DEPARTMENT OF THE ARMY  
Omaha District, Corps of Engineers  
106 South 15th Street  
Omaha, Nebraska 68102-1618

Amendment No. 0001  
23 July 2003

SUBJECT: Amendment No. 0001 to Specifications and Drawings for Construction of  
CONVENTIONAL AIR LAUNCH CRUISE MISSILE (CALCM) BEDDOWN, PDC NO.  
QJVF 042002P1, MINOT AFB, NORTH DAKOTA.  
Solicitation No. DACA45 03 B 0002.

TYPICAL REINFORCING AT PENETRATIONS  
NO SCALE

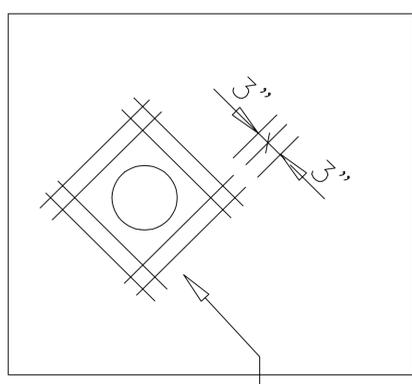
(1) Sheet U3.01: Revise as follows:

- a. Replace DOUBLE CHECK DETECTOR VALVE AND VALVE DETAIL in accordance with attached sketch.
- b. Add TYPICAL REINFORCING AT PENETRATIONS in accordance with attached sketch.
